Headington Liveable Streets

Comments & questions on your proposed LTN filter locations

OLD HEADINGTON LTN

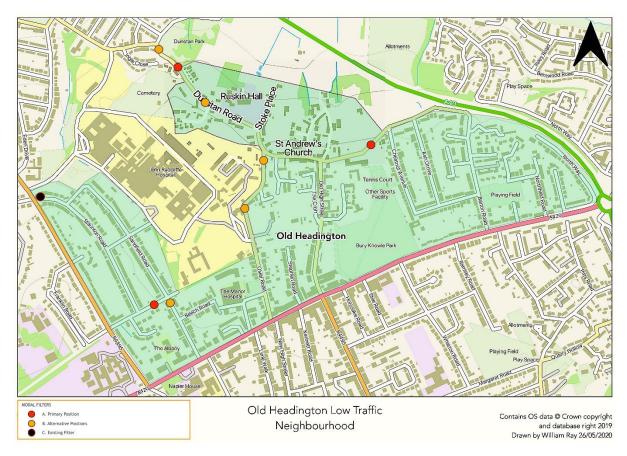
Response from and friends of Old Headington¹

"Our goal is to reduce through traffic on

- the east-west axis through the village (Barton Lane <> St Andrew's Road <> Dunstan Road) &
- Osler Road from St Andrew's Road south to the JR Hospital entrance

This can be achieved by active travel filters on Dunstan Road and Osler Road **or** on Dunstan Road and Barton Lane.

We think it is important to consult affected neighbourhoods and make decisions on trial locations based on feedback.
